COUNCIL SUBMISSION – Sydney Metro West - Parramatta Metro Station - Over and Adjacent Station Development EIS (SSD- 35538829) - public consultation

City of Parramatta Council (Council) thanks the Department of Planning and Environment (DPE) and Sydney Metro West (SMW) for the opportunity to provide a submission to the public consultation for the Parramatta Station – Over and Adjacent Station Development EIS (SSD- 35538829). Council looks forward to continuing to work closely and proactively with SMW on this critical Project for the City of Parramatta.

Figure 2- Soil depth & utility requirements

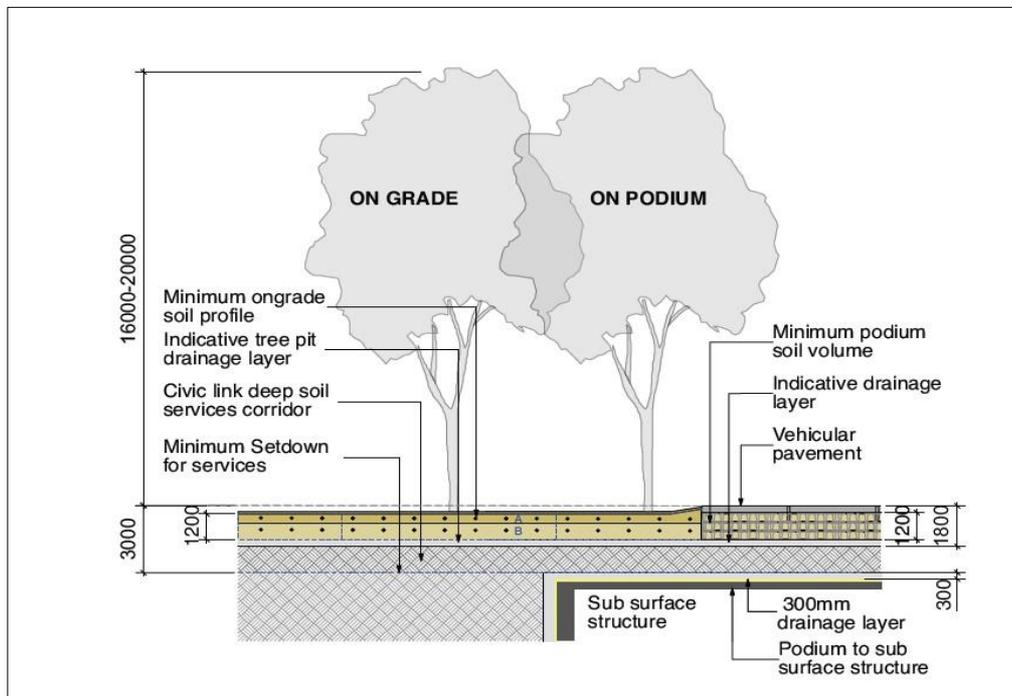
- New public spaces - Civic Link, Welcome Square and New Horwood Place – are supported by CoPC, but these spaces require tree planting that can be sustained in the long term for the performance and amenity of the city. A continuous line of tree planting along Civic Link is a key attribute of the Civic Link Framework Plan endorsed by Council in 2017 and as reinforced by the City Centre DCP.
- Council has provided advice to SMW on the design development for Civic Link and a Draft Design Brief with performance requirements. Where a structure is proposed underground, a nominal depth of soil zone of 1500mm from finished paving level to top of drainage layer within an overall depth of 3m to support utilities and services is required to ensure the health and longevity of trees as per Figure 2.

The building envelope drawings and Design Guidelines are amended to set out below ground development extents in relation to the finished level of the public domain at ground and include soil depth and utilities/service requirements above structures.

Figure 3- Proposed Tree Canopies

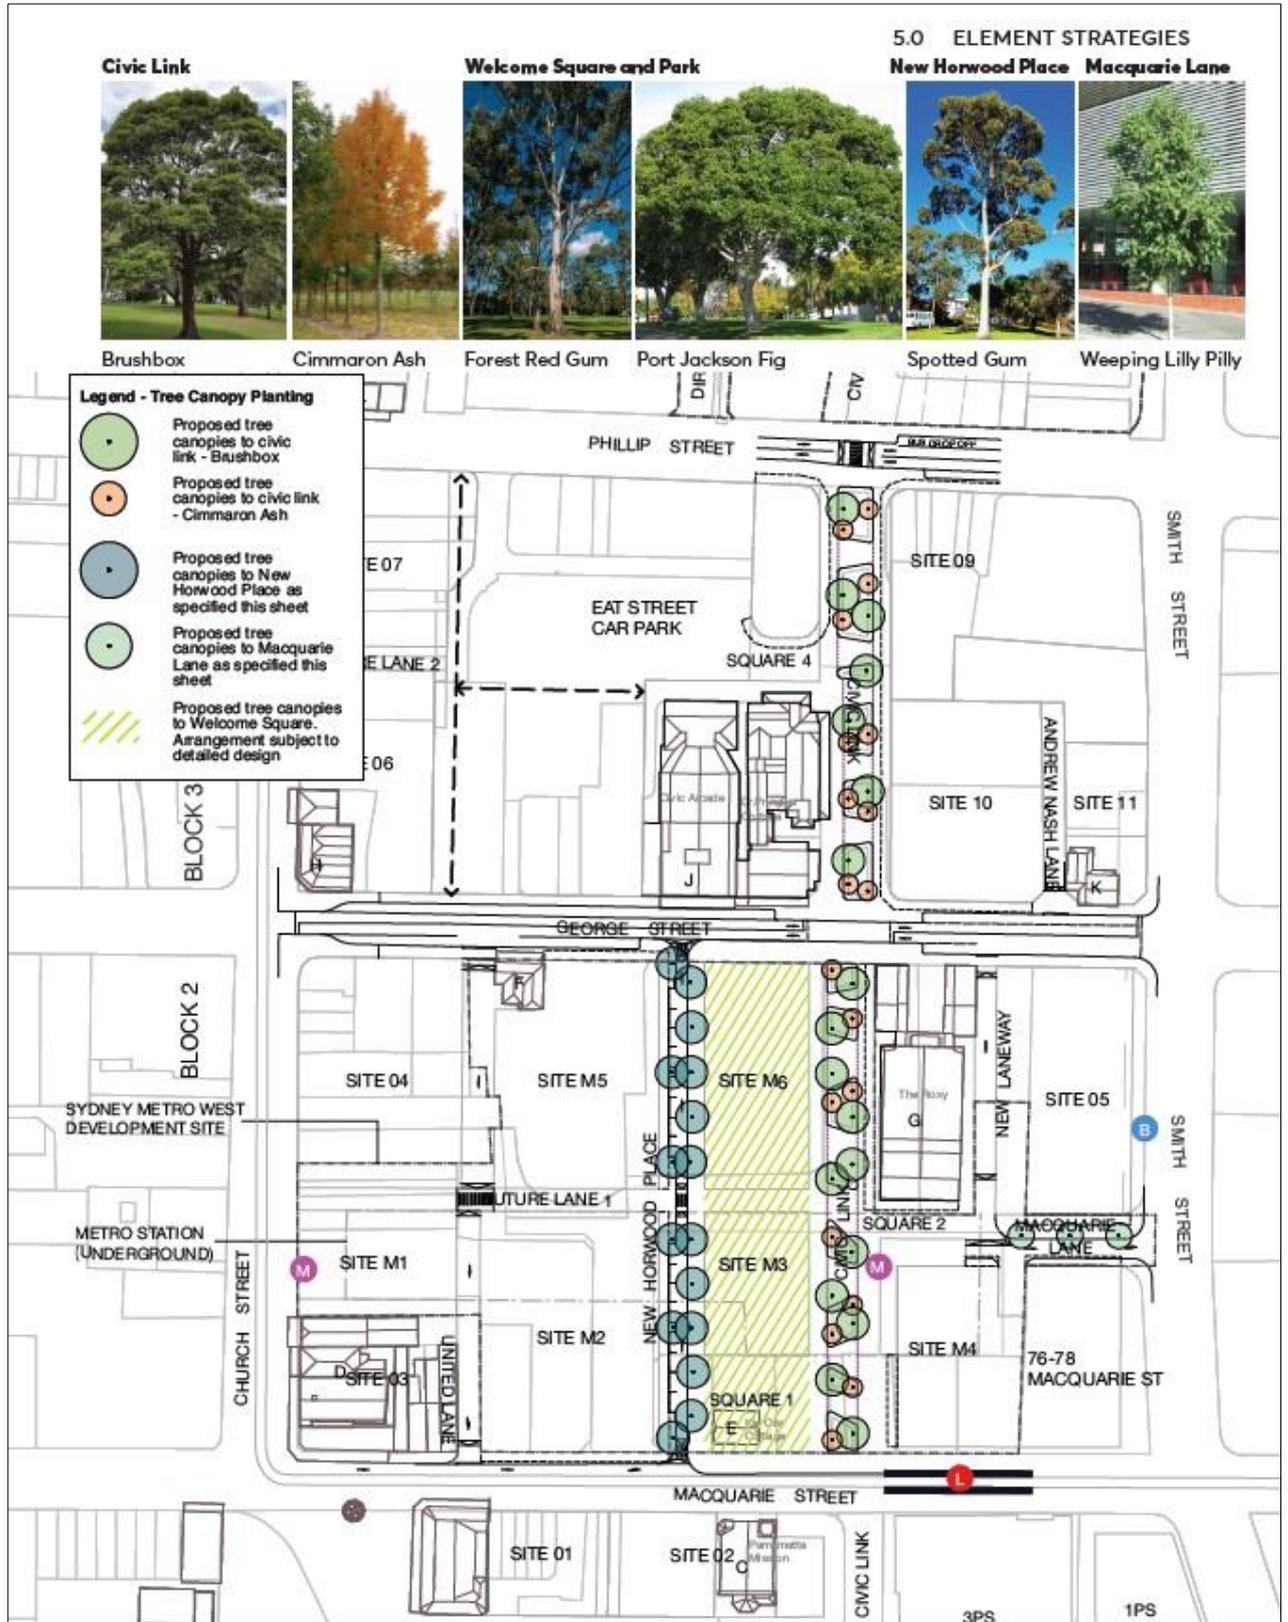
- Civic Link in the EIS documentation is shown with a discontinuous tree canopy with breaks adjacent the Metro Station and along the side of the Roxy. This is not acceptable. Council's Design Brief demonstrates how tree canopy, pedestrian movement to the station and seating can be accommodated together to ensure consistent tree canopy along Civic Link as per Figure 3 below.

Figure 4- City Centre DCP setbacks

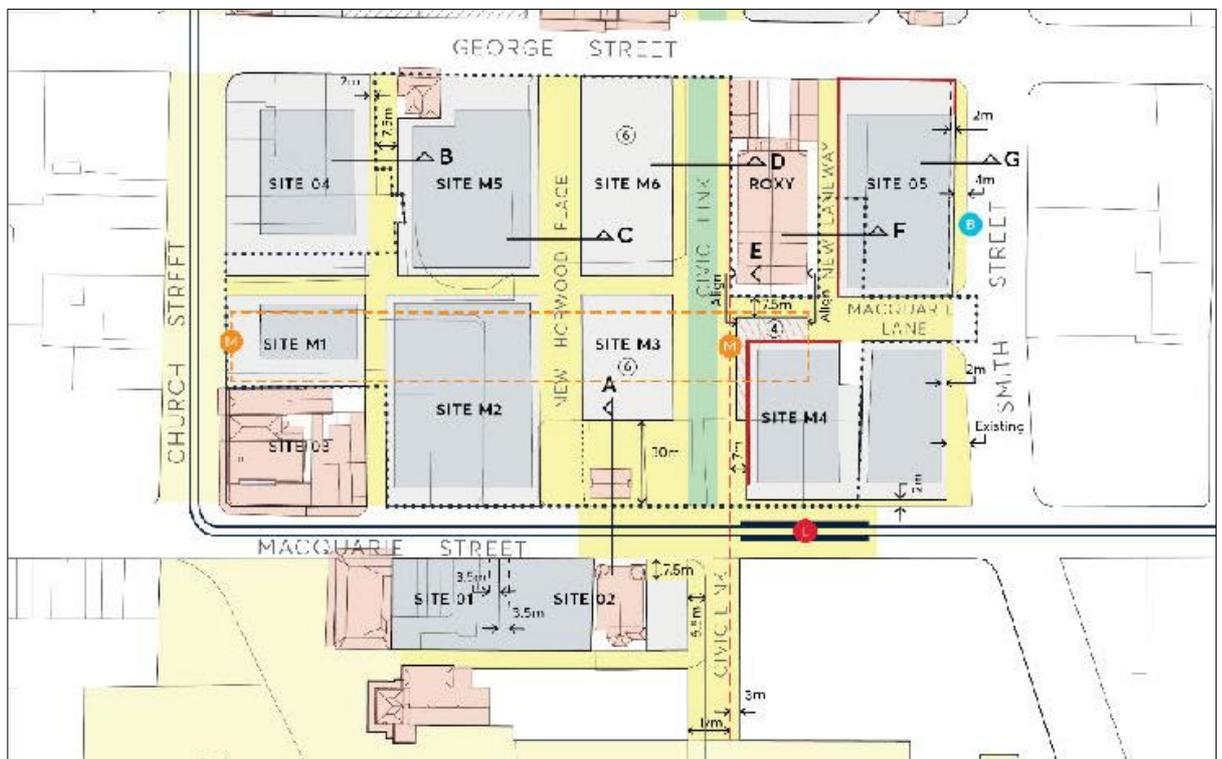
The proposal has not addressed site access to properties in the north-east and north-west corners of the block, which are in fragmented ownership. Council’s DCP supports amalgamation of these properties to realise the objectives of the City Centre and support the commercial core zoning with appropriate development footprints.

- Northeast corner at Smith Street and George Street (Site 05 in Council’s DCP below) – Council’s DCP describes a preference for the amalgamation of 71 (part, on grade carpark), 73 and 75 Smith Street to facilitate commercial development in alignment with the City Centre LEP and DCP. Piecemeal outcomes on individual sites also result in poor access solutions for the 3 properties and for the adjacent Roxy Theatre. The retention of the on-grade carpark to the east of the Roxy is a poor public domain outcome in the heart of the city centre and conflicts with pedestrian access between the proposed bus interchange at Smith Street and the Metro Station.

- Northwest corner at Church Street and George Street (Site 04 in Council’s DCP below-Figure 4) – Council’s DCP describes a preference for amalgamation of the multiple small properties facing Church St and George Street in the north-west corner of the block. Existing service access to buildings facing Church Street rely on an easement across the Metro site. There are no drawings that show how access to these properties will be achieved in their existing condition and in the future condition with the proposed Metro development.

Additional information is to be provided that show how vehicle and service access properties is provided for properties adjacent Metro for both existing fragmented development and for future development under Council's LEP/DCP.
